UNITED STATES PATENT AND TRADEMARK OFFICE

APPLICATION NO.	FILING DATE	FIRST NAMED INVENTOR	ATTORNEY DOCKET NO.	CONFIRMATION NO.
10/822,245	04/12/2004	Rodney L. Richardson	MIM1755	1789

Office Action Summary

DETAILED ACTION

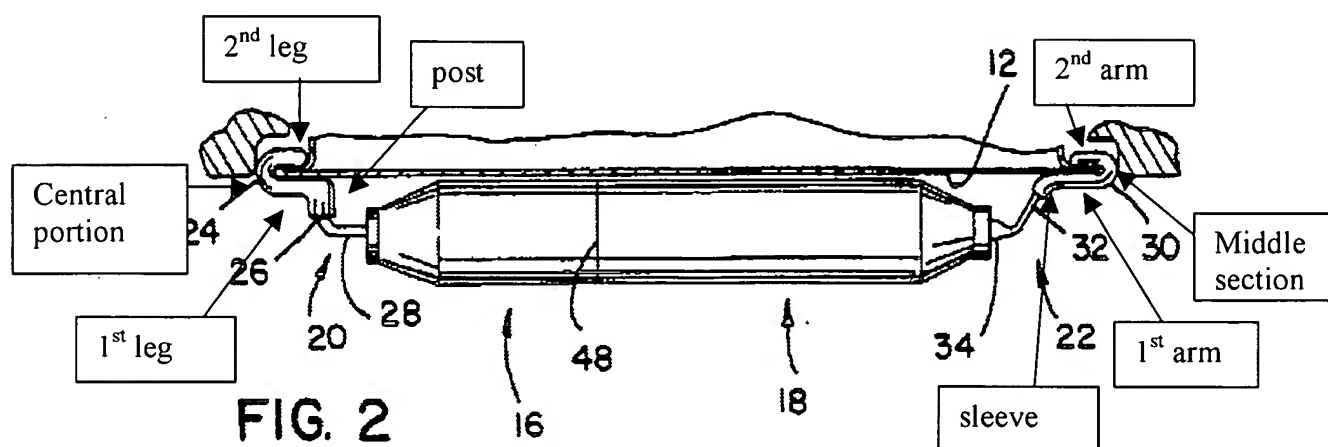
Regarding claim 2, Wille et al. disclose the device according to claim 1, wherein said first coupler includes a first leg, a second leg and a central portion (see below) attached to each of said first and second legs such that said first and second legs extend in generally the same direction with respect to each other, the first edge being selectively positioned between said first and second legs, a post being attached to said first leg, said post being attached to said first end of said rod such that said first and second legs extend toward said second end of said rod. Wille does not disclose that the post extends in the same direction as said first leg. It would have been obvious to one of ordinary skill to orient the post such that it extends in the same direction as the

first leg. The motivation would have been to allow the rod to be made as a straight member to make manufacturing of the rod simple and inexpensive.

Regarding claims 6-8, Wille et al. disclose the device according to claims 2-4, wherein said second coupler (30) includes a first arm, a second arm and a middle section (see above) attached to each of said first and second arms such that said first and second arms extend in generally the same section direction with respect to each other, the second edge being selectively positioned between said first and second arms, a sleeve (see above) being attached to said first

arm, said second end of said rod (22) extending into and being attached to said sleeve such that said first arm extends toward and is aligned with said first leg. Wille does not disclose that the sleeve extends in the same direction as said first arm. It would have been obvious to one of ordinary skill to orient the sleeve such that it extends in the same direction as the first arm. The motivation would have been to allow the rod to be made as a straight member to make manufacturing of the rod simple and inexpensive.
